Title: **STAGE 1 ROAD SAFETY AUDIT**

Proposed Residential development at Milltown Park, Sandford Road, Dublin 6.

Client: **DBFL Consulting Engineers.**

Report reference: **0995R01**

Drawing 190226-DBFL-RD-SP-DR-C-1001 P02, Roads layout.

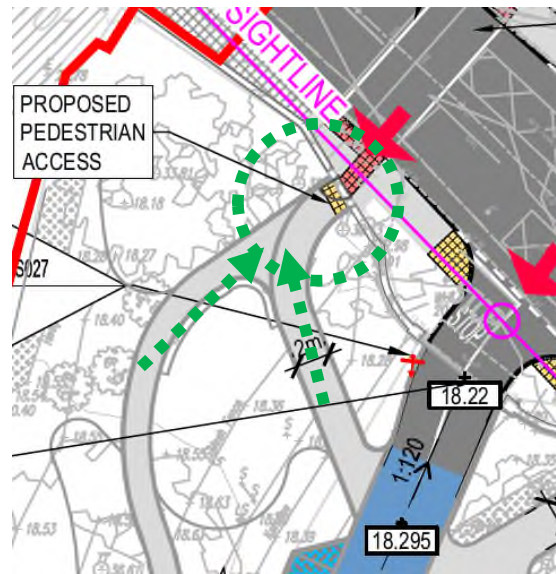
The width of the section of shared use area for pedestrian and cyclists on approach to the north western access onto Sandford Road may not be sufficient to cater for both user groups and could lead to collisions.

It is recommended that a wider shared area be provided to avoid collisions between cyclists and pedestrians.

Paragraph No. in Safety Audit Report	Problem accepted (yes/no)	Recommended measure accepted (yes/no)	Alternative measures (describe)	Alternative measures accepted by Auditors (Yes/No)
3.1	Yes	Yes		
3.2	No	No	The shared area width in question is acceptable as cyclists will primarily access from Sandford Road via the 4.8m wide shared access. We also note that there is constraints on the shared area width in question due to trees / existing walls.	Yes
3.3	Yes	Yes		
3.4	Yes	Yes		
3.5	Yes	Yes

Drawing 190226-DBFL-RD-SP-DR-C-1001 P02, Roads layout.

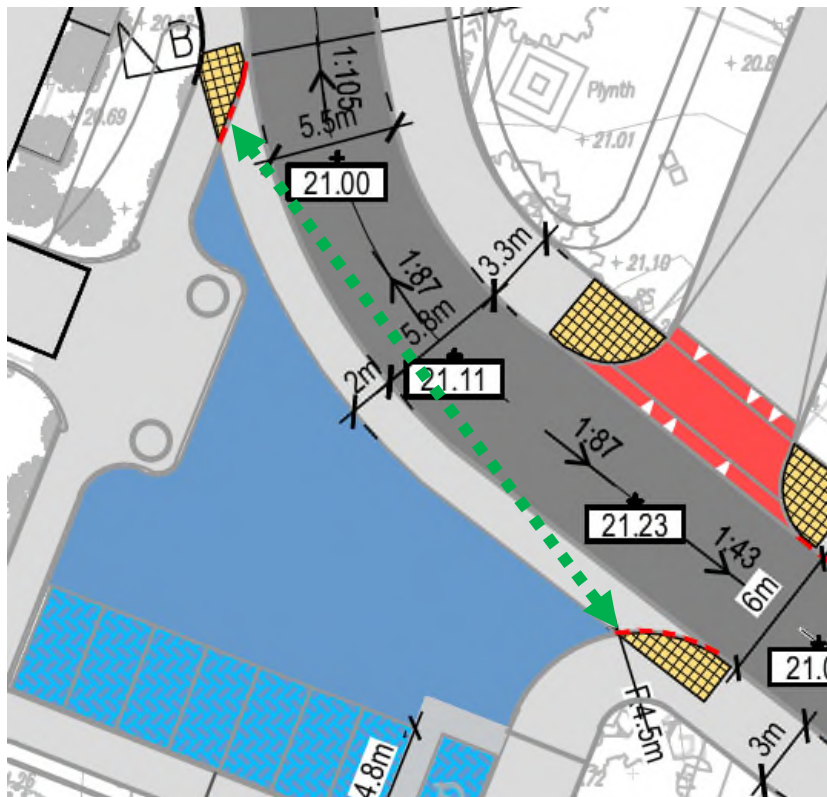
It is proposed to have dropped kerbs and tactile paving across the parking area in front of Tabor House. This is a wide area with a horizontal curve and blind or partially sighted pedestrians may inadvertently enter the carriageway where they would be at greater risk of being struck by a passing vehicle.

It is recommended that the footpath be made continuous with a 25mm lip for vehicular access that can be detected by blind or partially sighted individuals.

Drawing 190226-DBFL-RD-SP-DR-C-1001 P02, Roads layout.

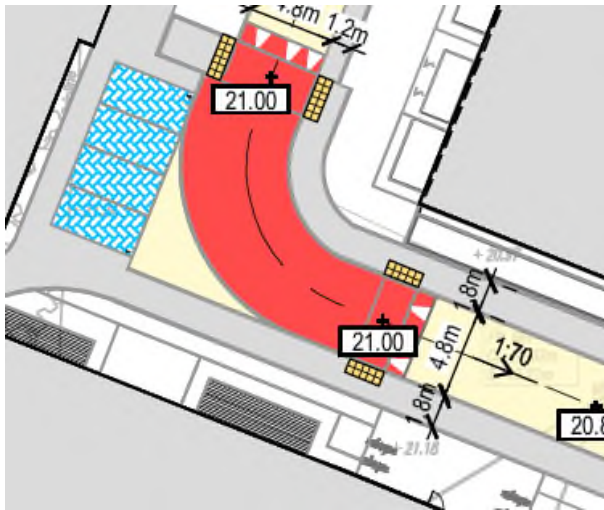
Between Block D and Block E there is a 90 degree bend in the carriageway which has a width of 4.8m. There is a risk of side swipe collisions if vehicles meet at the bend. In addition, the uncontrolled crossing appears to protrude beyond the edge of carriageway.

It is recommended that a swept path analysis be carried out and if necessary localised widening of the carriageway should take place.
